T10/08-433r0

SAS_PHY: Comments on sas2r14g

Mathieu Gagnon
PMC-Sierra

Figure 133 – Reference transmitter device termination S-parameters

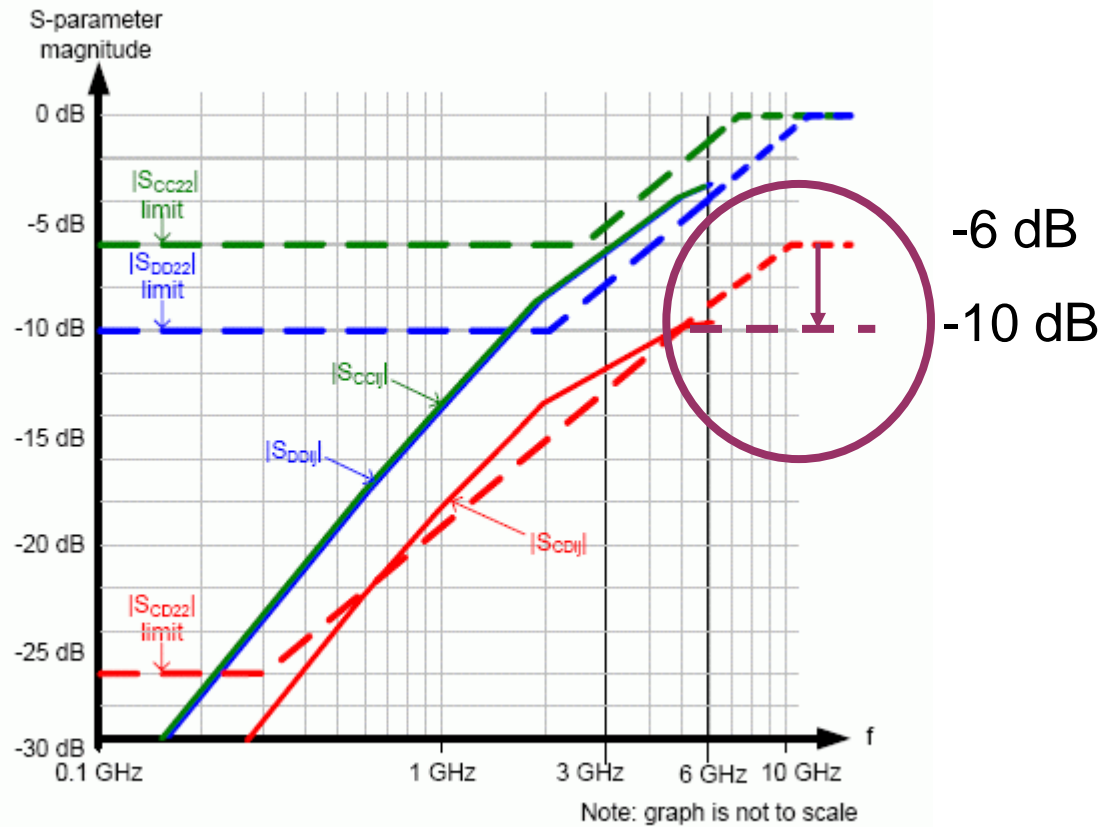
- The graphs of the S-parameters Spec. have incorrect high-frequency asymptote for S_{CD22} parameter
- Figures 131, 133, 136 and 138
- Furthermore, the paragraph before Figure 133 refers to the wrong figure.

Figure 138 shows the S-parameters of the reference transmitter device termination model.
